Item Name: Bar

DART AEROSPACE LTD		Work Order: 134504
Description: Bar		Part Number: D3196-1
Inspection Dwg: D3196	Rev: C	Page 1 of 1

DRAWING NO. D3196	TITLE BAR	REV. C	DART AEROSPACE LTD ENGINEERING ORDER		D.E.O. NO. D3196-C-1	SHEET NO. SHEET 1 OF 2	SCALE NTS
DRAWN <i>ASS</i>	CHECKED <i>[Signature]</i>	MFG. APPR. <i>[Signature]</i>	APPROVED <i>[Signature]</i>	DE APPR. <i>[Signature]</i>			
DATE 08.08.27	DATE 08.08.28	DATE 08.08.29	DATE 08.08.29	DATE 08.08.29	DATE 08.09.04

D3196-1 BAR

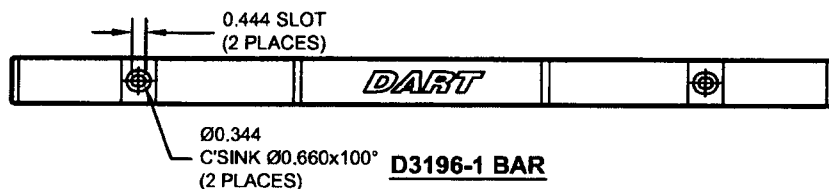
SHEET 1 MODIFY SLOT DIMENSIONING ON D3196-1 AS SHOWN:

D3196-3 BAR

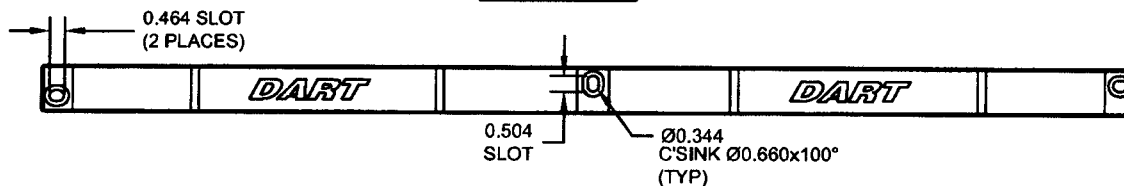
SHEET 2 MODIFY SLOT DIMENSIONING ON D3196-3 AS SHOWN:

D3196-4 BAR

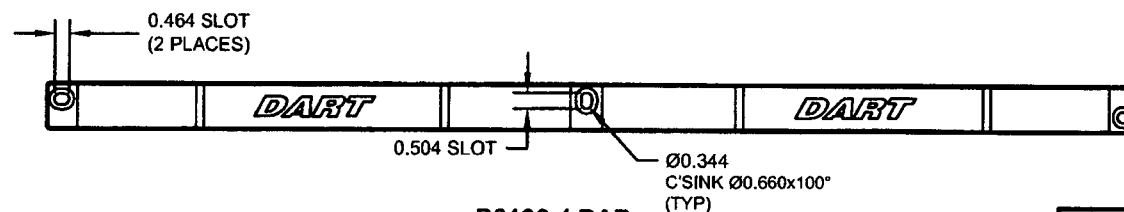
SHEET 3 MODIFY SLOT DIMENSIONING ON D3196-4 AS SHOWN:
